CALIFORNIA DIVISION OF MINES AND GEOLOGY
FAULT EVALUATION REPORT FER-242
*** SUPPLEMENT No.1 ***

FLEXURAL SLIP FAULTING NEAR PICO CANYON
Los Angeles County, California

May 17, 1995

Figure 1 (FER-242, supp.#1) - Index map to tracts, faults and selected trenches, including and adjacent to Stevenson Ranch (Tract 33698). Faults recommended for zoning (A-F) are highlighted.

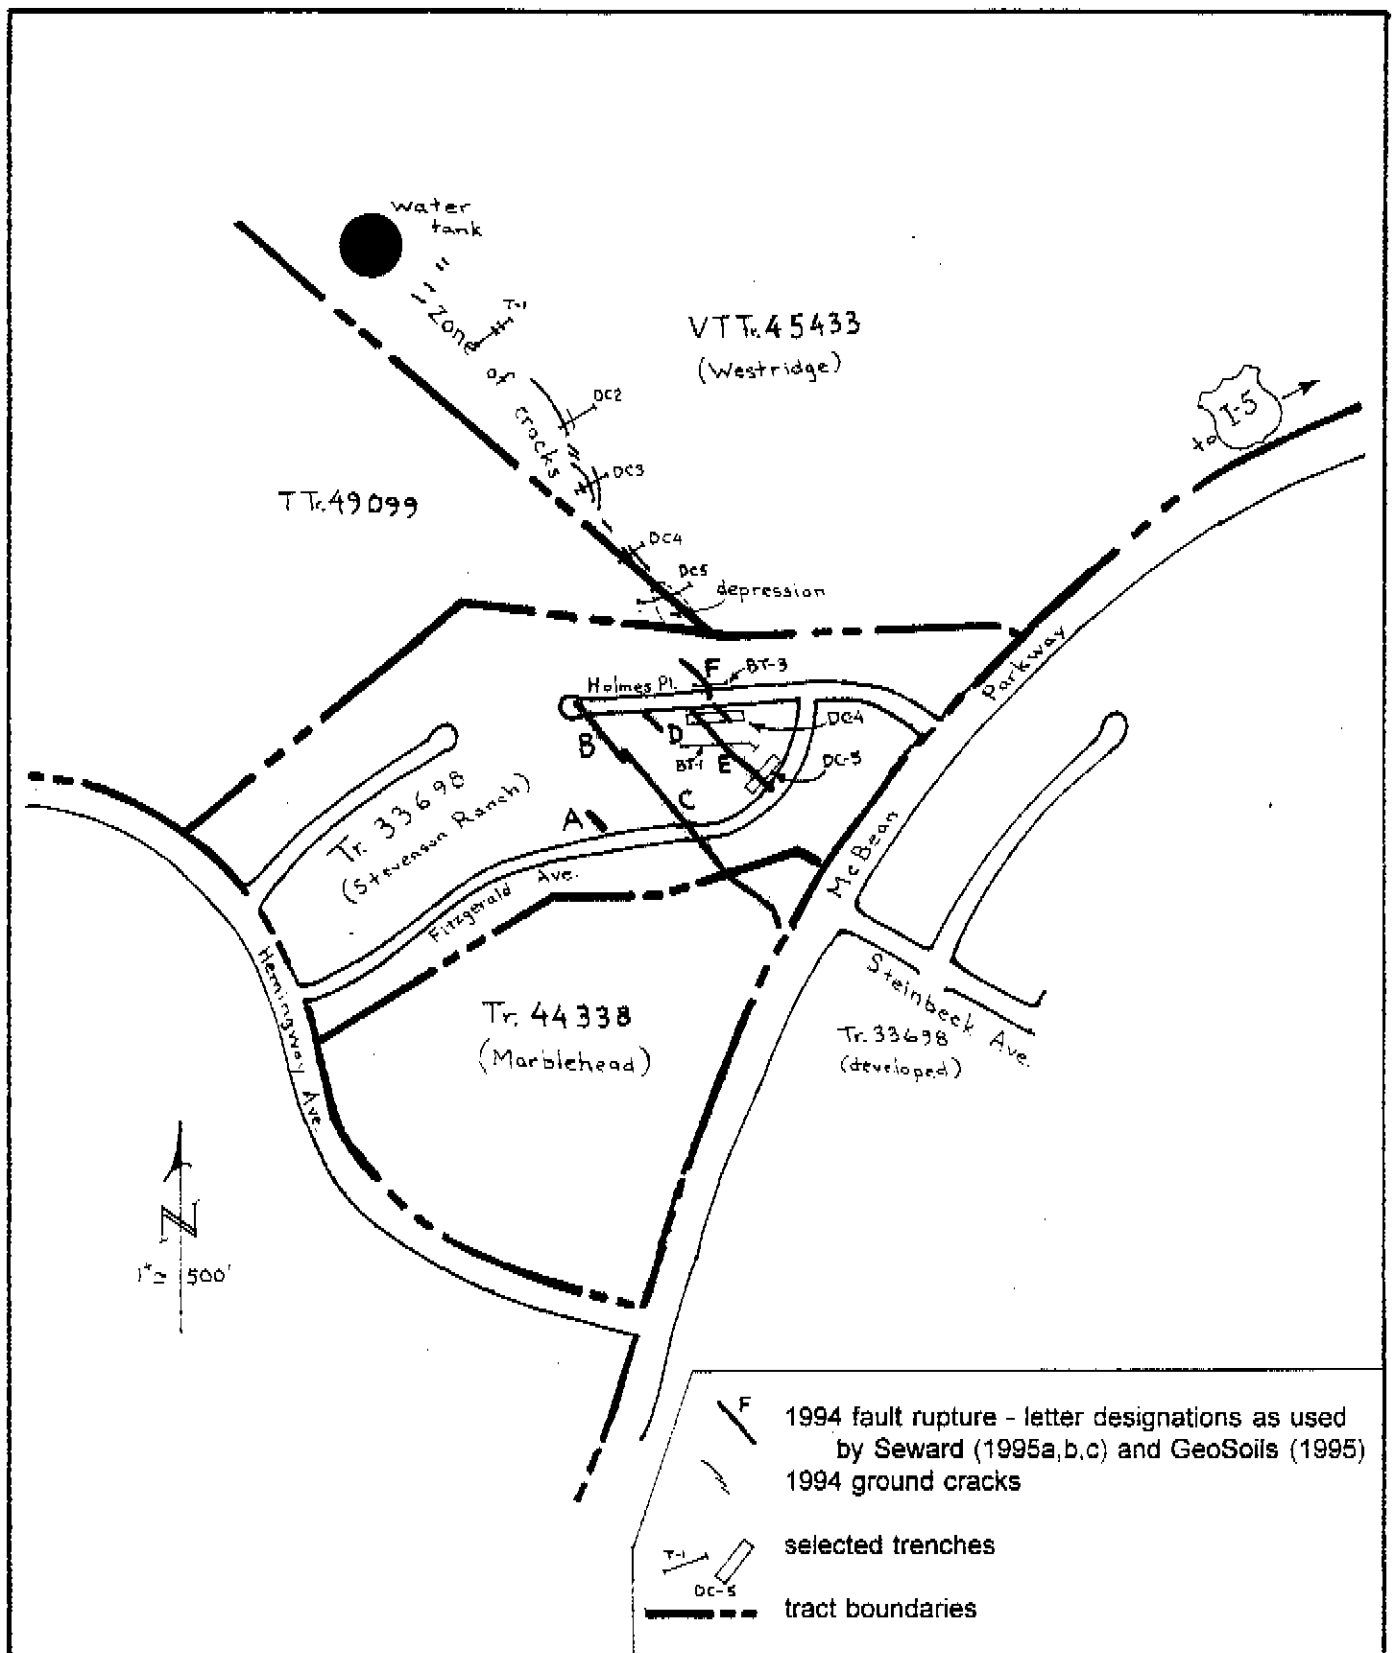
New data and interpretations have been offered to try to disprove the interpretation of 1994 faulting across three adjacent landholdings (Figure 1). The two principal properties are a graded (but not developed) portion of Stevenson Ranch (Tract 33698) and undeveloped land to the north (Westridge, Vesting Tentative Tract 45433). A smaller affected area (Marblehead, Tract 44338) lies to the south. Surface fracturing, displacement and deformation are acknowledged to have occurred across these properties, however the consultants for the property owners (GeoSoils, 1995; Seward, 1995a,b,c) contend that the surface effects are related to unusually strong shaking and are not tectonic. New data on these issues include logs from extensive trenching and several borings. Refer to FER-242 (Treiman, 1994) for a more thorough description of the earthquake related surface features. The proposed Earthquake Fault Zone also extends across an undeveloped portion of Tentative Tract 49099 and into a developed part of Tract 33698 (southeast of McBean Parkway) however no surface fractures were observed within these properties.

Surface displacements at the Stevenson Ranch and Marblehead developments have been identified along faults labeled A through F (see Figure 1). The displacements are interpreted by the consultants to be the result of seismically triggered elastic rebound as a response to prior removal of up to 83 feet of bedrock from a ridgeline (GeoSoils, 1995; Seward, 1995b,c). They claim that the greatest amount of uplift coincided with the area of deepest removal. A post-earthquake survey (of part of the graded area only) showed that the ground between faults B/C and E/F had been elevated (relative to the adjacent terrain)

up to one foot (GeoSoils, 1995). Most of this relative uplift occurred near faults B/C and E/F although some uplift was distributed between and beyond these two bounding fault zones. Faults A, D and E were considered minor (with 2cm or less vertical offset) and no building setbacks were recommended. Faults B and C had the largest surface displacements (up to 19cm) and are closely related by a short stepover. Fault D is near the contact between Saugus Formation and the overlying mid- to late-Quaternary sands and gravels of the Pacoima Formation. Fault E is adjacent to what Seward (1995c) calls a zone of tensional deformation at the eastern margin of the principal uplift. Fault F, also near the eastern uplift boundary, is recognized by GeoSoils (1995) but is not discussed by Seward (1995c).

The proposed zoning (CDMG, 1994) should be reduced to include only the well-defined faulting within the graded area (Figure 1). Within the graded areas of Stevenson Ranch and the Marblehead development clear co-seismic faulting has occurred along shears with ample evidence of prior displacements (Ruptures A-F). The area recommended for zoning also includes a narrow well-defined active fold or flexure with internal thrust faulting across bedding. Tectonically related surface warping is so narrowly constrained that it may damage a structure built across it. Structures should be set-back from the bending-moment thrust faults within the core of the concave-up fold as well as from bedding-plane faults within the Earthquake Fault Zone boundaries.

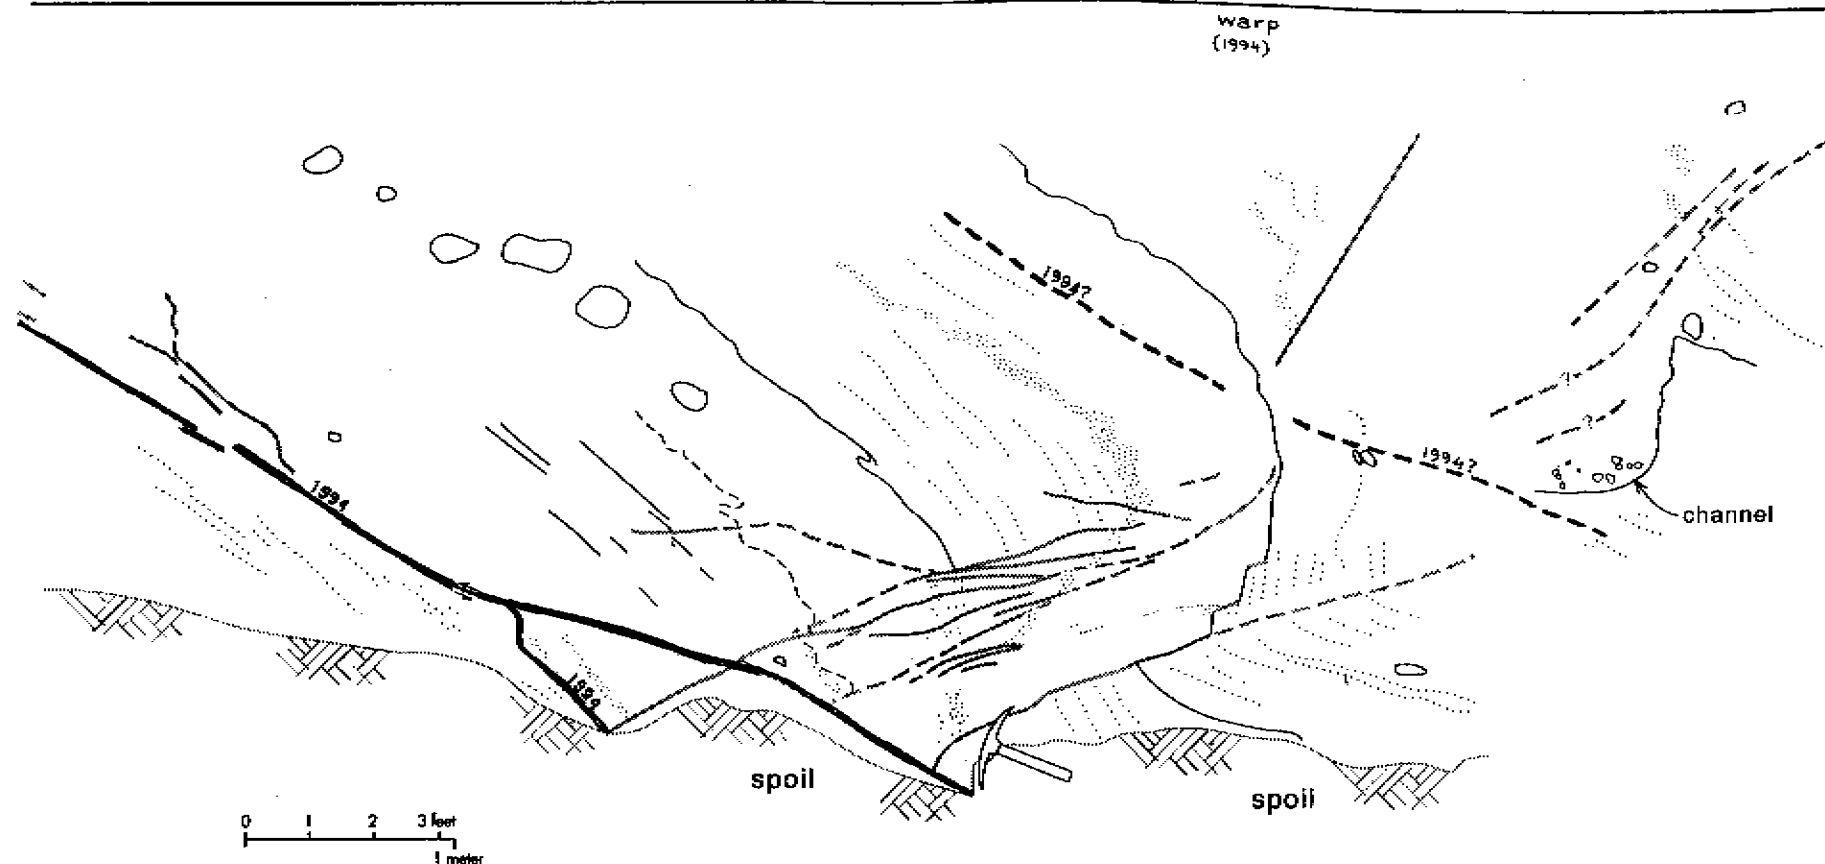
Seward (1995c) logged only the south wall of Trench DC-4 from Stevenson Ranch. GeoSoils (1995) logged both walls. I am including my own log of the north wall of DC-4 (Figure 2). I did not have the opportunity to see the deeper backhoe trench within this bulldozer trench.

Seward (1995c, p.26) argues that the distress adjacent to Rupture E (and F) is tensional. However, his trench logs across this zone show no tension features. They do show reverse faults that cut across the bedding, bedding-plane shear surfaces associated with the January 1994 reverse surface displacements, and compressional folding. Ruptures E and F are reverse bedding-plane faults which require shortening rather than extension. Although some of the surface cracks may appear to be tensional the overall deformation in this zone is clearly compressional.
